ADDENDUM

Project Name:	Village of Beverly Hills Village Hall Office Renovation	Addendum No:	One (1)
Project Number:	15-161	Issue Date:	April 15, 2015
Project Location:	The Village of Beverly Hills, Michigan

To the Contract Documents for the requested Village of Beverly Hills Village Hall Office Renovation.

1
A3-01
Floor Plan - New Work
1/8" = 1'-0"

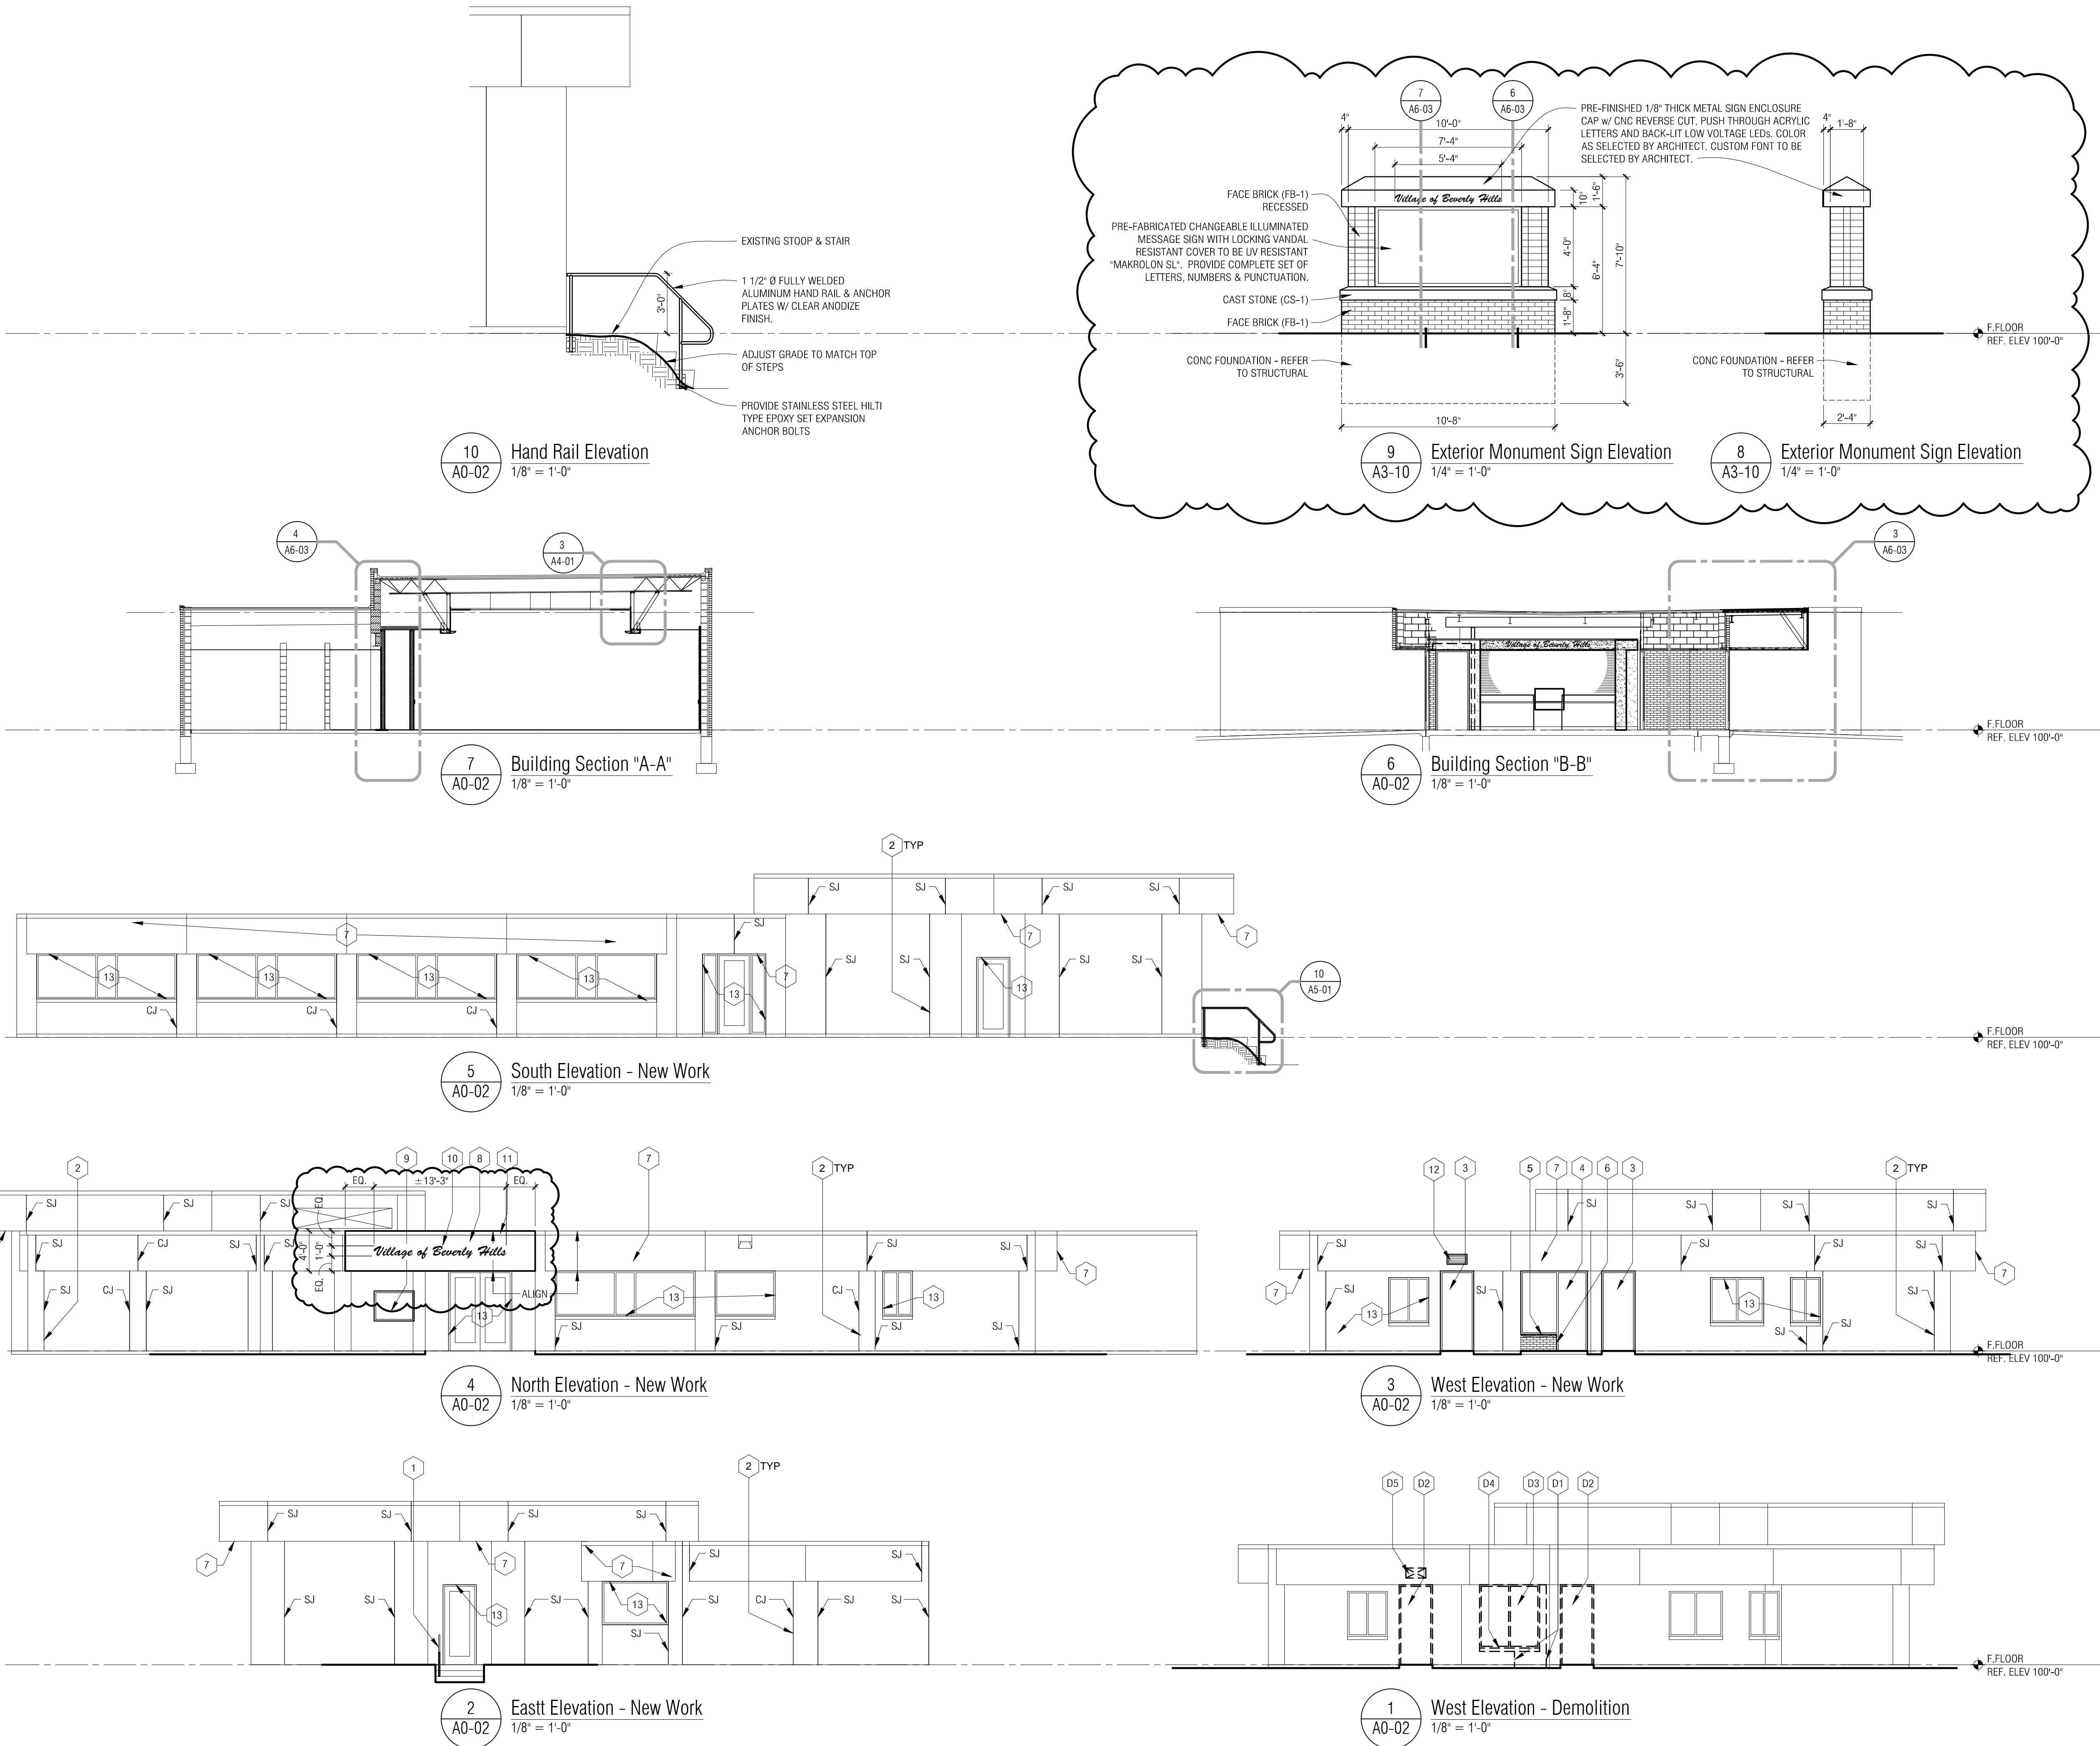
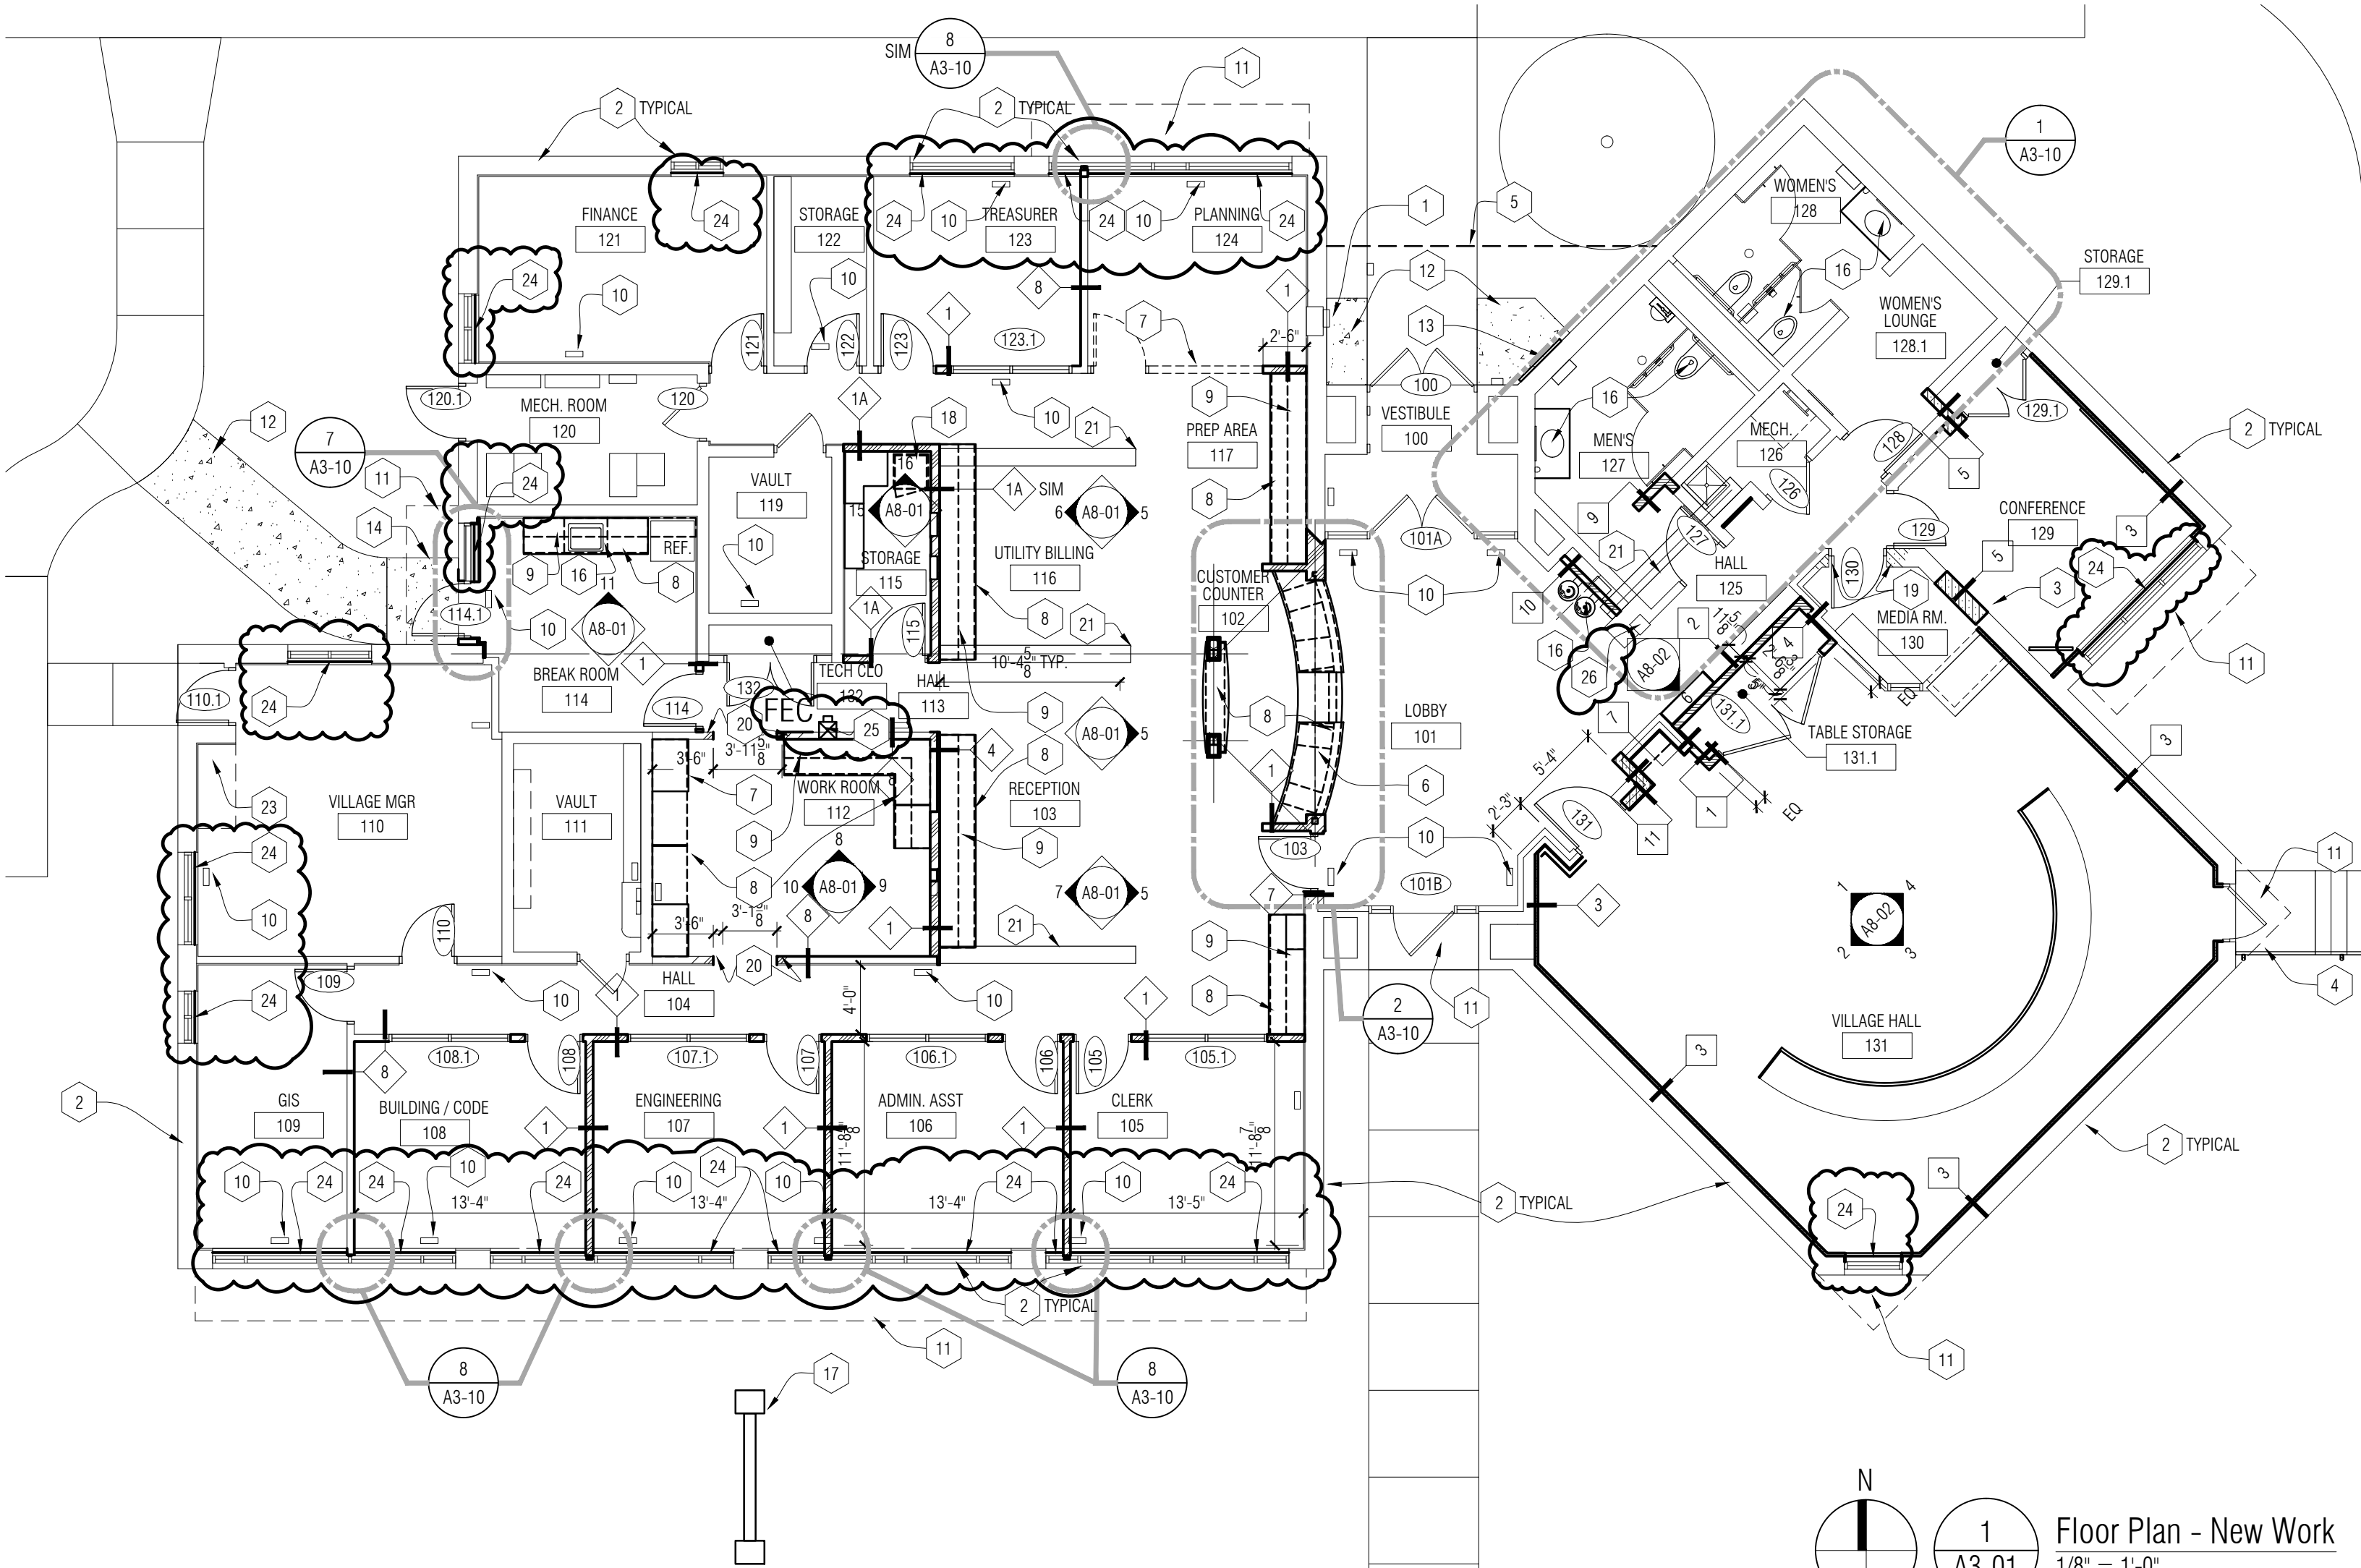
- Item A4** Drawing A3-01; Floor Plans – New Work and Floor Finish Plan (revised and reissued this Addendum)
- A. Added new Floor Plan Key Note # 24 to read: "New roller shades. Verify all dimensions in field. Refer to Detail 7/A4-01 for above ceiling support header."

- B. Added new Floor Plan Key Note # 25 to read: "New fire extinguisher and semi-recessed cabinet.
 - C. Added new Floor Plan Key Note # 26 to read: "Existing fire extinguisher and cabinet to remain.

- D. Added location of new fire extinguisher and cabinet to Floor Plan – New Work (noted with new keynote 25 added this addendum).
 - E. Added location of existing fire extinguisher and cabinet to Floor Plan – New Work (noted with new keynote 26 added this addendum).

- F. Added "CPT-4" to Finish Floor Plan Legend
 - G. Added locations of new roller shades to Floor Plan – New Work (noted with new keynote 24 added this addendum).

- H. Revised Floor Finish Plan:
 - a. Revise Floor Finish Keynote in rooms 120, 128, 128.1, 130, and 131.

- 22 REMOVE AND REINSTALL EXISTING TRASH RECEPTAL AS REQ'D FOR NEW CONCRETE WALK.
- 23 NEW PLAM CAP ON EXISTING CABINET
- 24 NEW ROLLER SHADES. VERIFY ALL DIMENSIONS IN FIELD. REFER TO DETAIL 7/A4-01 FOR ABOVE CEILING SUPPORT HEADER.

- 25 NEW FIRE EXTINGUISHER AND SEMI-RECESSED CABINET
- 26 EXISTING FIRE EXTINGUISHER AND CABINET TO REMAIN

A5-01

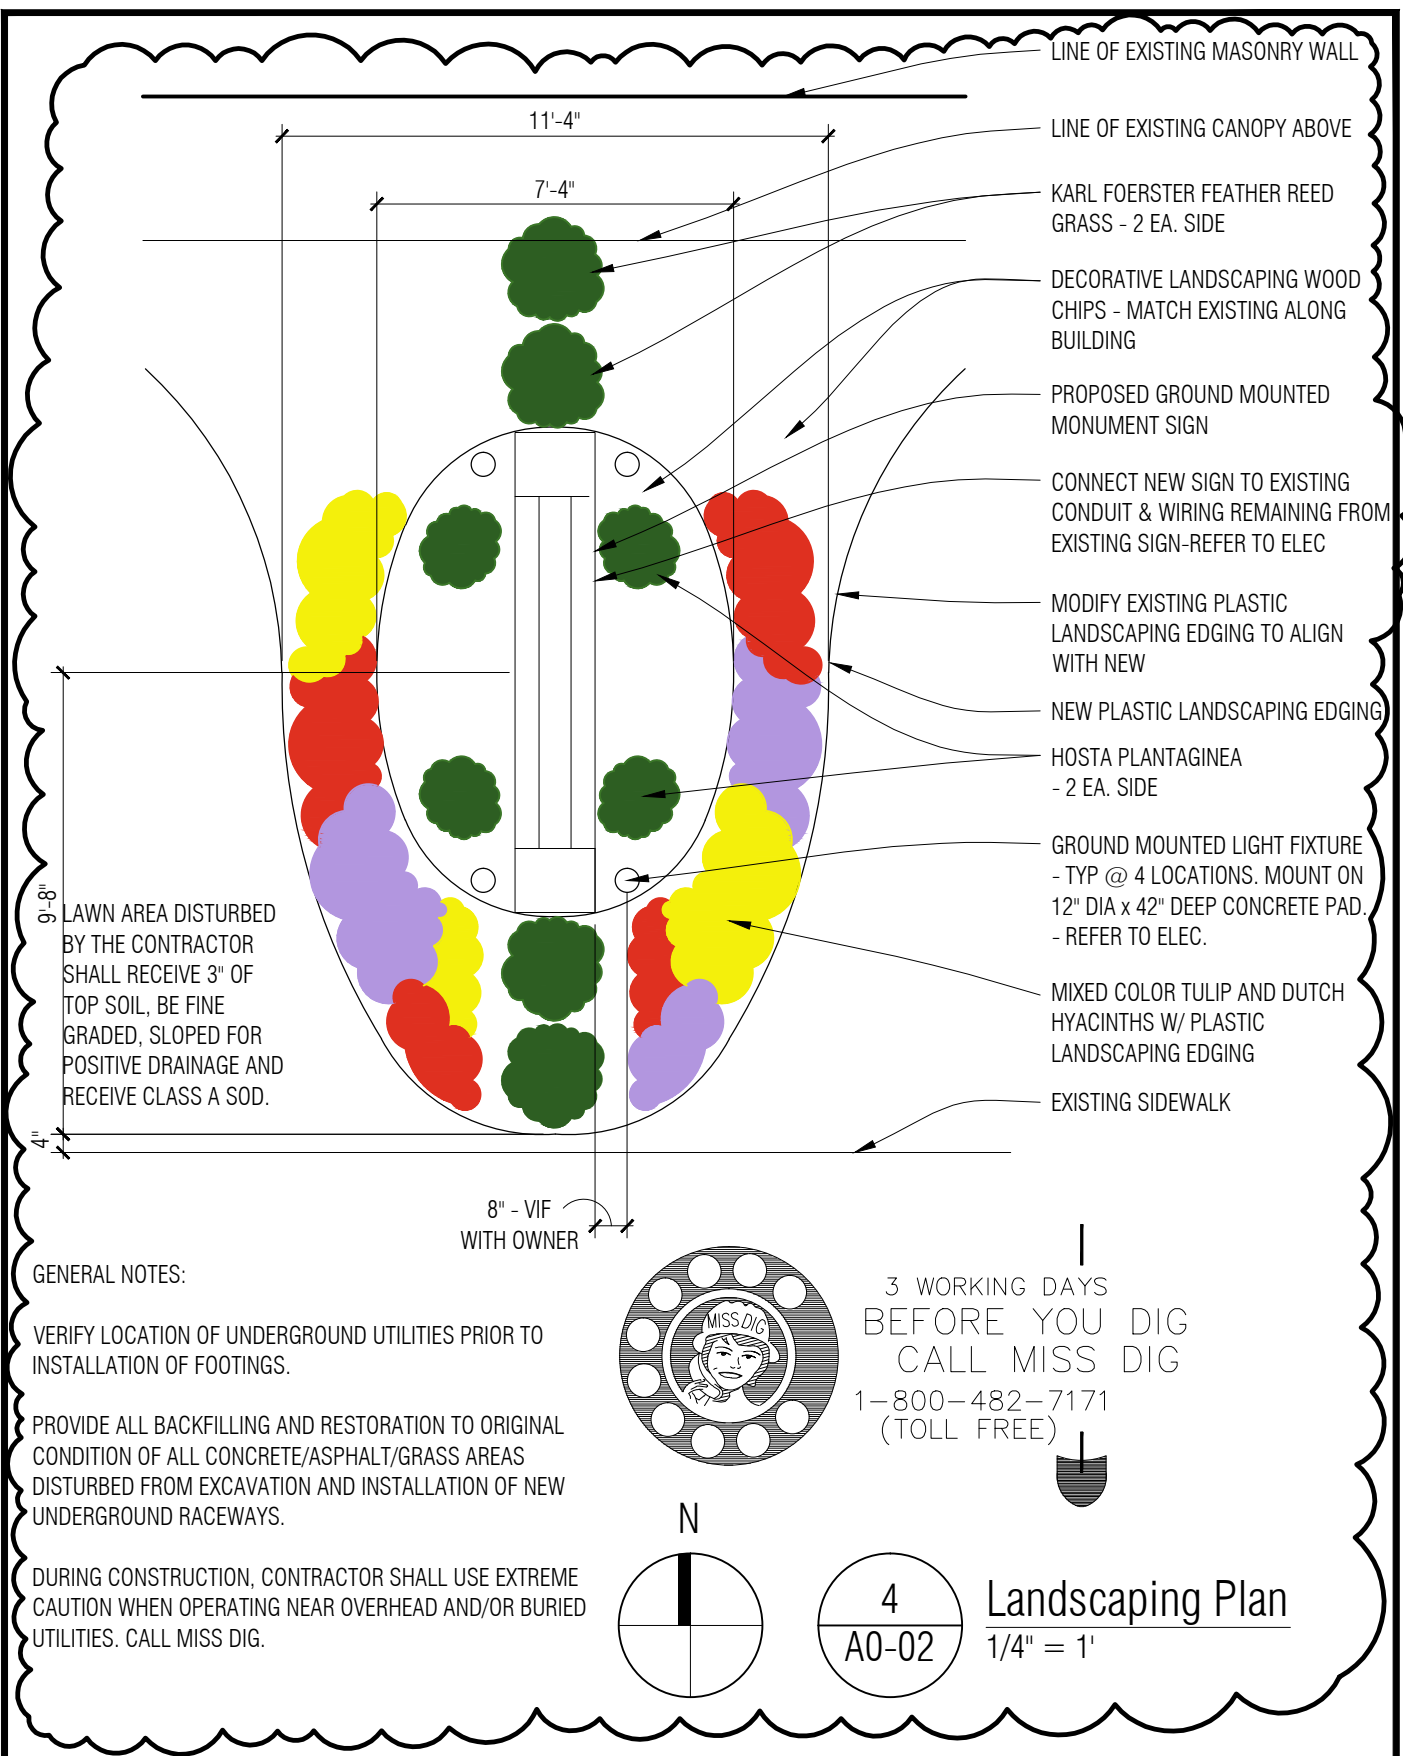
- Item A7** Drawing A5-01; Exterior Elevations & Building Sections (revised and reissued this Addendum)
- A. Revised Elevation 4/A0-02 reduces exterior signage from 14" high channel letters to 12" high channel letters.

- B. Revised Exterior new work elevations – key note # 10 to read: “12” channel letter signage. Alternate #2: 12” led halo-illuminated channel letter signage in lieu of non-lit channel letter signage.”
- C. Revised Elevation 8/A3-10 & 9/A3-10 enlarges the exterior monument sign in both height and width.

- 7 REPAIR AND PAINT EXISTING FASCIA AND SOFFIT
- 8 NEW 'DEFS' PANEL SYSTEM.
- 9 LOCKABLE VISUAL DISPLAY BOARD CABINET.
- 10 12" CHANNEL LETTER SIGNAGE
ALTERNATE #2: 12" LED HALO-ILLUMINATED CHANNEL LETTER SIGNAGE IN LIEU OF NON-LIT CHANNEL LETTER SIGNAGE.

DRAWING REF.:
 SK-1

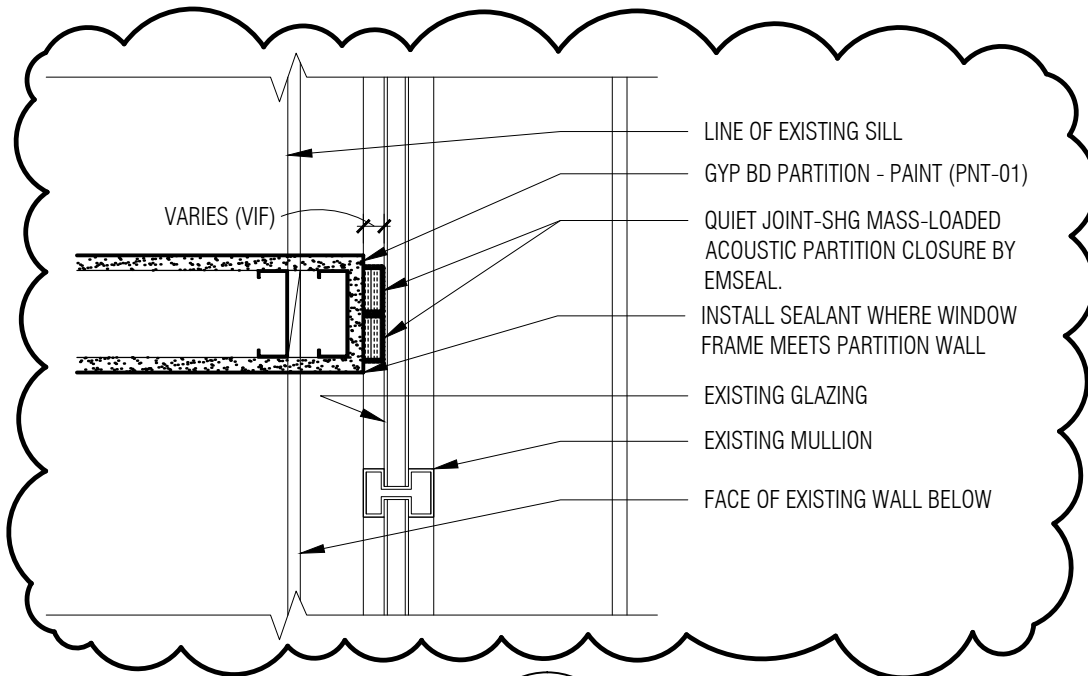
Item A1 Drawing A0-02; Composite Floor & Site Plan (not reissued this addendum) & SK-01; Landscaping Plan (issued this Addendum)

- A. Add Landscaping Plan detail to clarify extent of landscaping and revise detail @ new ground mounted monument sign.
